# Grameen Fabrics & Fashions Ltd. (11501)

25.June.2014

# Identified Priority 1 Concerns

## 1<sup>st</sup> Priority 2 Concern

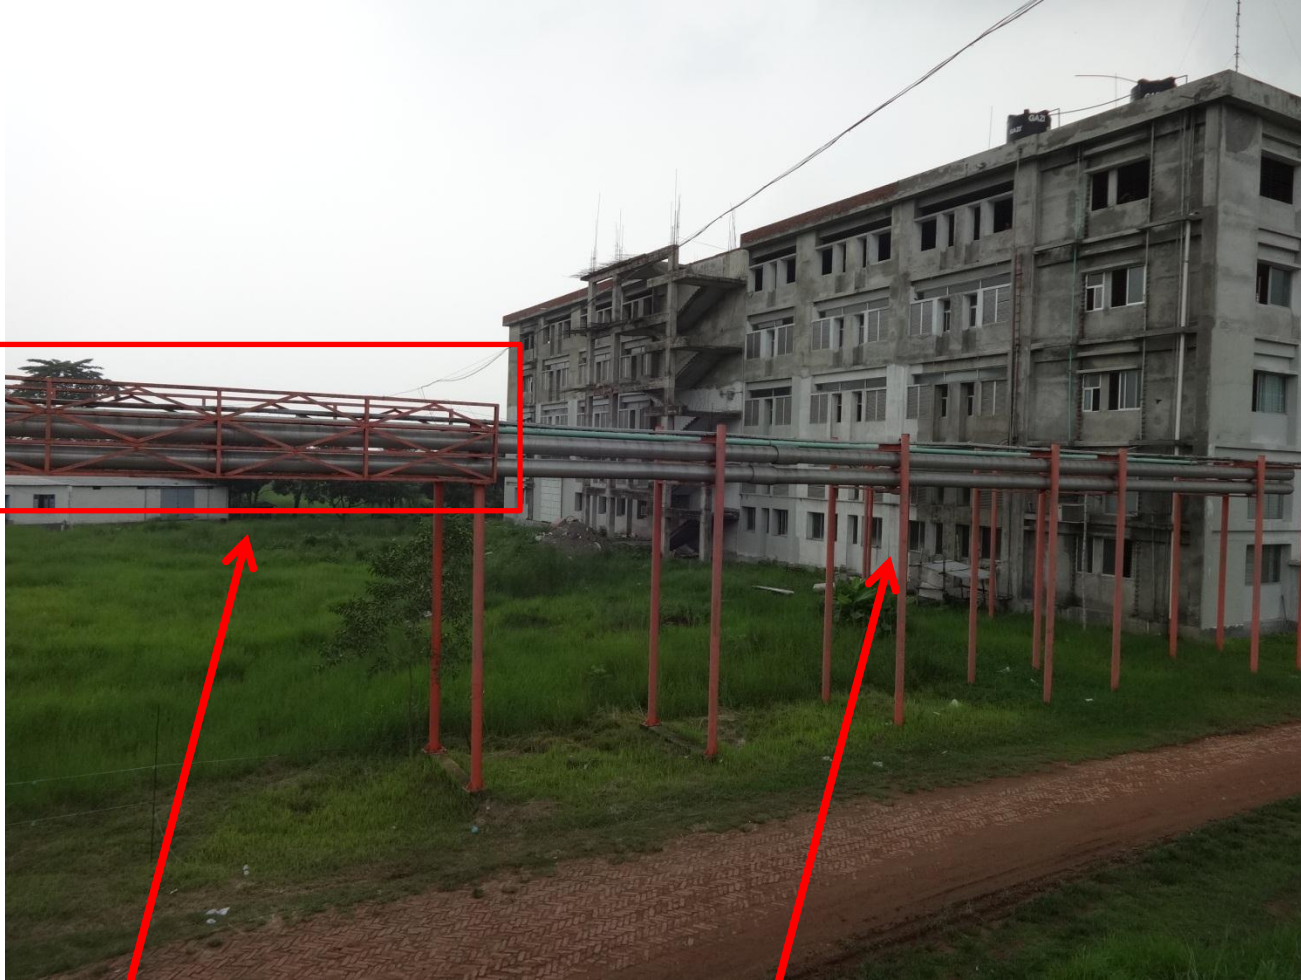
Telecommunications mast on the roof of the main factory is not adequately guyed down to the slab.

Guy wires are connected to a steel angle which does not appear to be adequately sized or fixed to the slab.

### 3<sup>rd</sup> Priority 2 Concern Continued

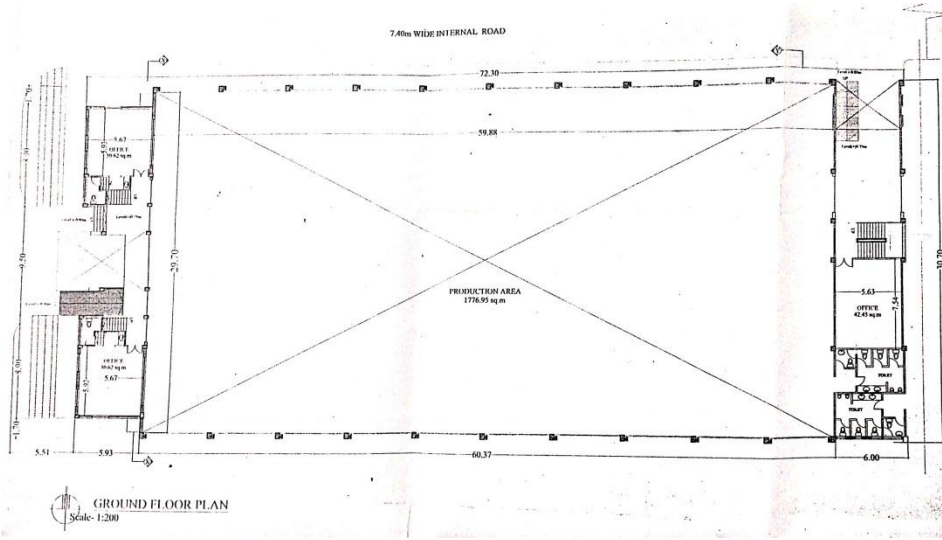
Pipes supported on brackets cantilevered off concrete columns. There are only 4 bolts each side holding the steel bracket to the concrete column.
